January 26, 2024

RE: Request of The Albert M. Higley Co. on behalf of Courtyard by Marriott for PCA (Public Center Adjacent) Special District Review of proposed exterior alterations to 333 East Jefferson Avenue – Millender Center (**RECOMMEND APPROVAL WITH CONDITIONS**)

**A RESOLUTION AUTHORIZING ALTERATIONS IN A PCA
ZONING DISTRICT AT 333 EAST JEFFERSON AVE.**

Sheet
C-400

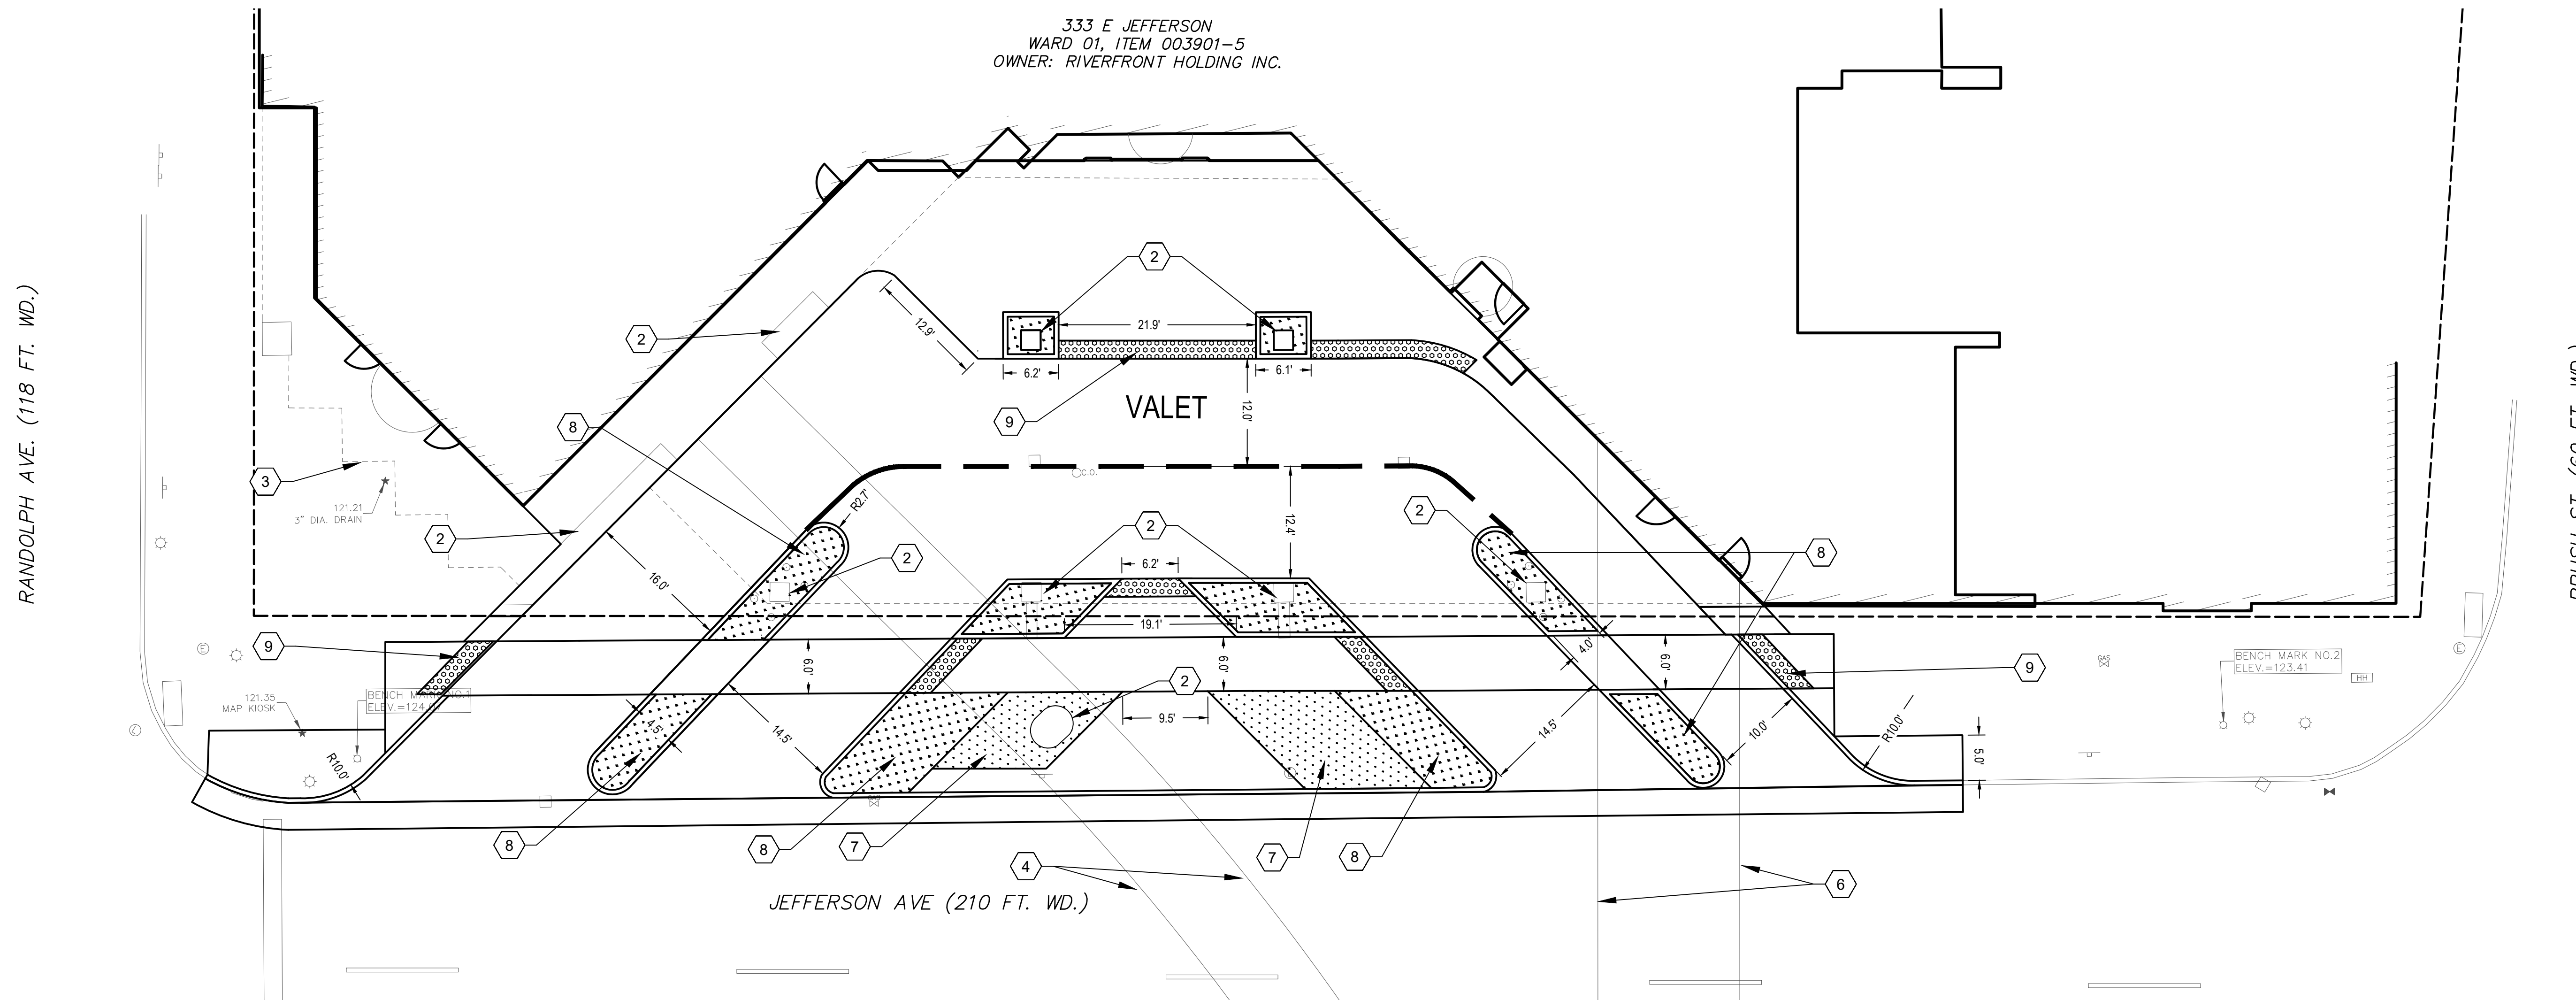
The Millender Center development includes multiple internal amenities and convenient and protected pedestrian access points and paths. However, staff was not able to identify any existing or proposed outdoor seating or bicycle storage amenities within or near the area of improvements. While this area functions primarily as a pass-through zone for hotel patrons and staff, it still may be beneficial to provide outdoor seating and/or a bicycle rack within or near the area of improvements as these outdoor amenities are not apparent. Additionally, the expanded pedestrian area near the building entrance should provide an opportunity for these amenities to be added to the site. Staff recommends outdoor seating, such as a bench, and/or a bicycle rack be added per this criteria.

1. That an outdoor seating area and/or a bicycle rack being added to the site plan in accordance with PCA District Review Criteria 16.
2. That the sign indicated on the Exterior Elevations be reviewed separately for compliance with Chapter 4 of the 2019 Detroit City Code.

1. That an outdoor seating area and/or a bicycle rack being added to the site plan in accordance with PCA District Review Criteria 16.

Sheet
A401.3

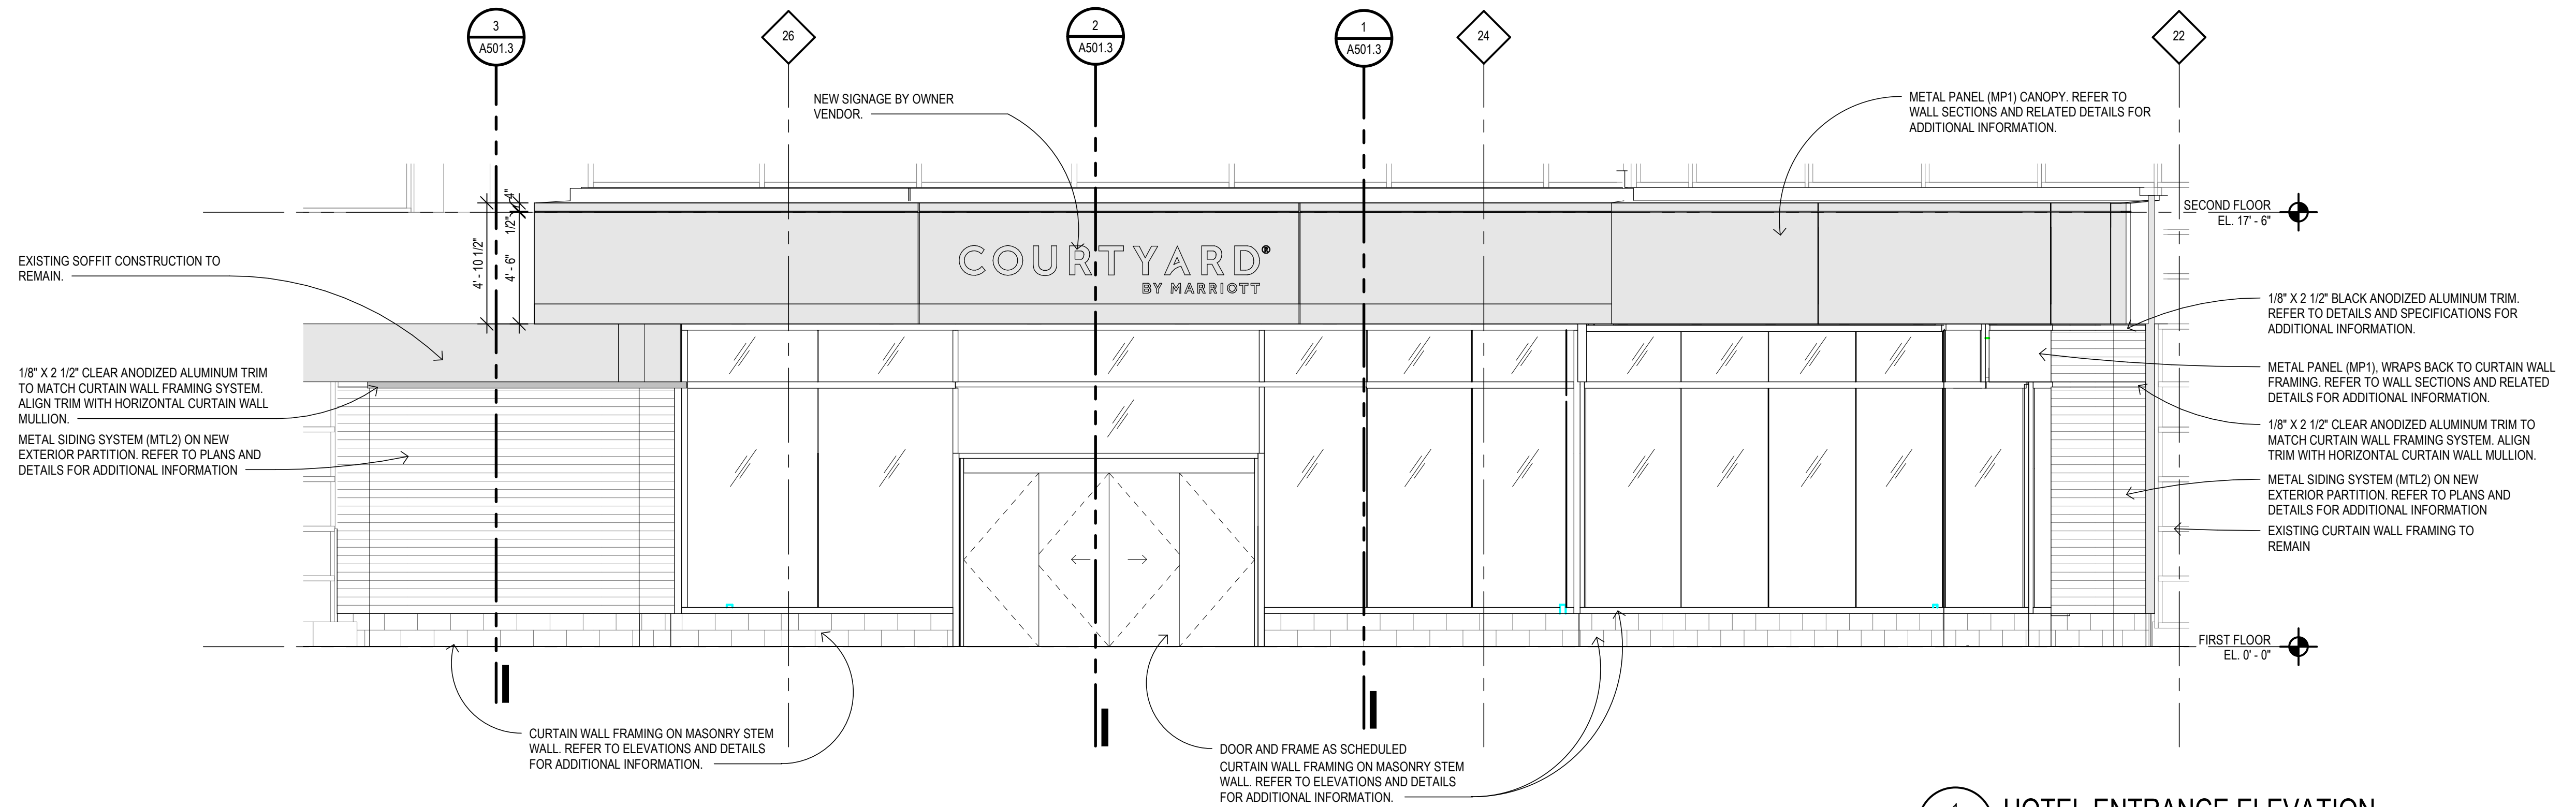
- A new Courtyard by Marriott sign is proposed above the new doorway. Please refer to the Exterior Elevations for details. Details for this proposed sign, as well as existing façade signage along East Jefferson Avenue have not been provided. The applicant has requested that signage be reviewed separately from this request as the sign design has not been finalized. Staff supports this request, and this is included as a recommended condition of approval for tracking purposes.

That the sign indicated on the Exterior Elevations be reviewed separately for compliance with Chapter 4 of the 2019 Detroit City Code
